CERTIFICATE OF APPROPRIATENESS

Applicant: Alexander Ridgeway of Brickmoon Design for Jerry and Mary Nelle Sinitiere, owner

Property: 1418 Ashland Street, Lot 25, Tract 24 and 26A, Block 152, Houston Heights Subdivision. The property includes a historic 1,194 square foot single family residence situated on a 8,712 square foot (66' x 132') interior lot.

Proposal: Alteration – Addition

NORTH ELEVATION – FRONT FACING ASHLAND STREET

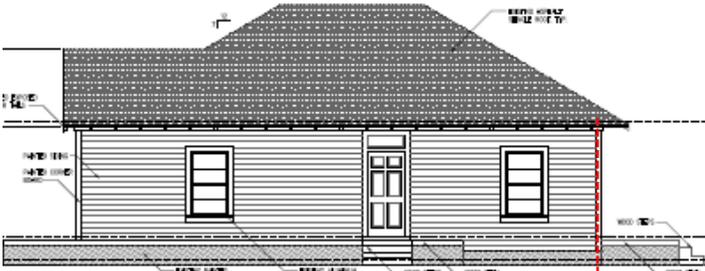
Front Elevation: A non-original front porch enclosure will be removed and a half width front porch will be restored.
(West) A non-original louvered vent on the porch canopy will be replaced with one of a slightly smaller size. An L-shaped circa 1998 pressure treated wood deck will be removed from the front and south sides of the structure. The addition will feature a two story section behind the structure and a one story component to the side of the two story addition. Both sections are proposed to be wider than the existing structure. The one story portion will feature a front porch with a gabled canopy and square columns, two pairs of 1-over-1 windows and a pair of French doors. The two-story portion will feature a gable and four 1-over-1 windows.

SOUTH SIDE ELEVATION

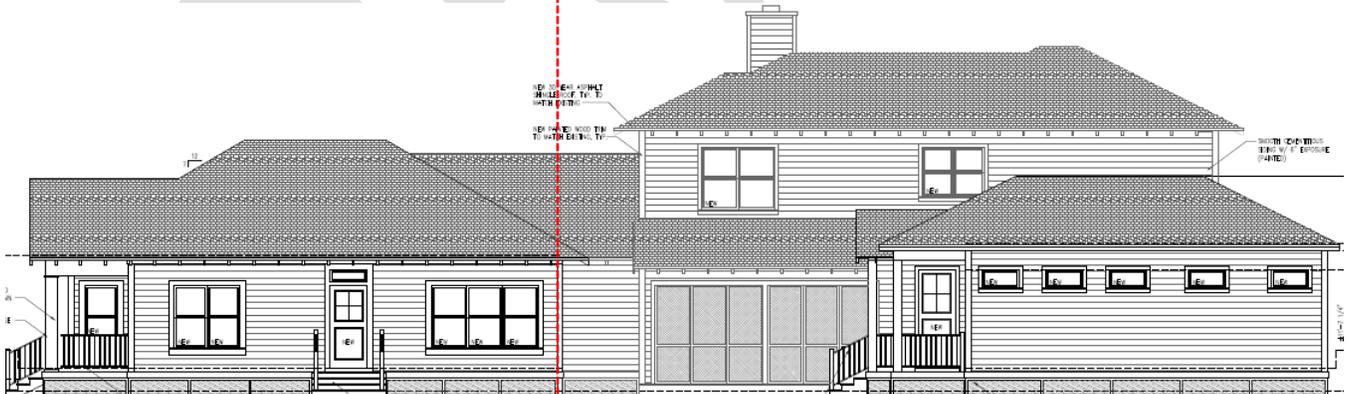
Side Elevation: The applicant proposes to replace two non-original aluminum windows with an adjoining pair of wood windows and an adjoining trio of wood windows. Staff inspection found that the historic studs and shiplap have long since been removed at these locations so the enlarged window openings will not result in a loss of any historic materials. A non-original side door will be replaced by a new 4-lite wood door. A set of wood steps and wood square railings will be installed to access the side entrance. The addition will feature four single-lite casement windows at the first floor and a row of three adjoining single-lite casement windows on the second floor.

NORTH SIDE ELEVATION

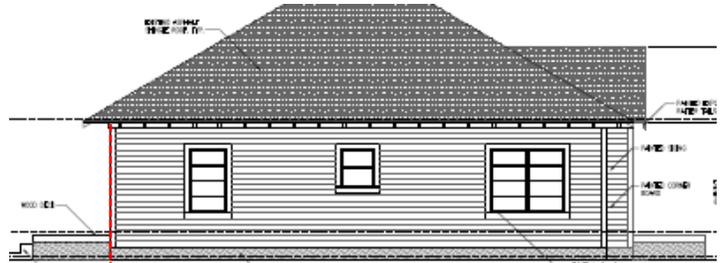
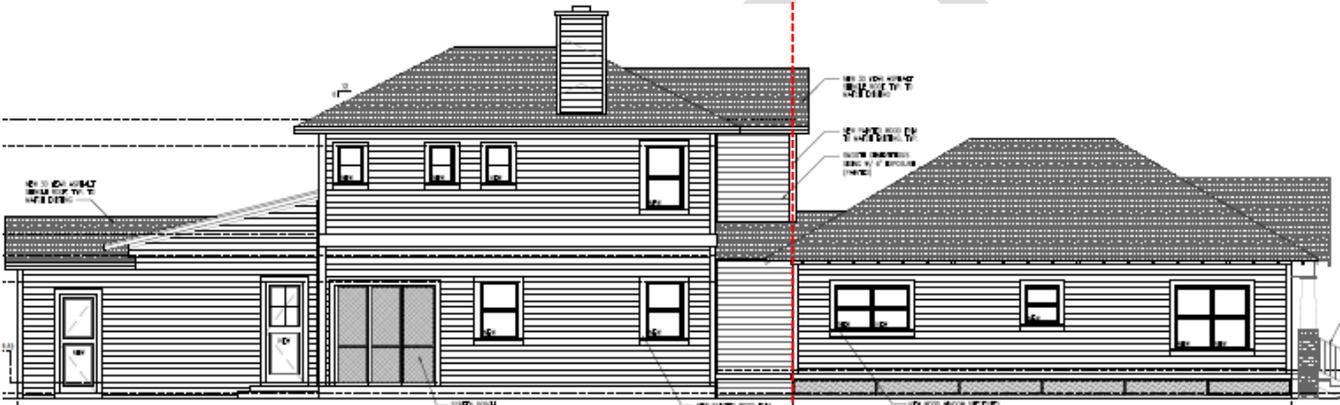
Side Elevation: The applicant proposes to replace four non-original aluminum windows with five wood 1-over-1 windows. The window opening at the rear of the north elevation will be widened to convert the window opening from single to double. Staff inspection found that the structural wall material at the proposed opening has long since been removed meaning the enlarged opening will not result in the loss of historic materials.
The addition will start at the rear of the existing structure. The addition will feature a pair of windows and a side screened porch on the first floor and 4 windows on the second floor.

EAST (REAR) ELEVATION

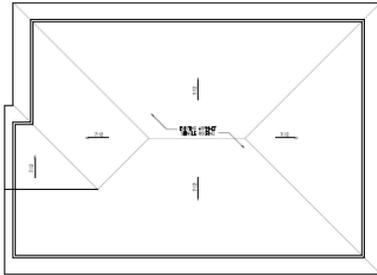
Rear Elevation: The east elevation will not be visible from the right of way.
(East)
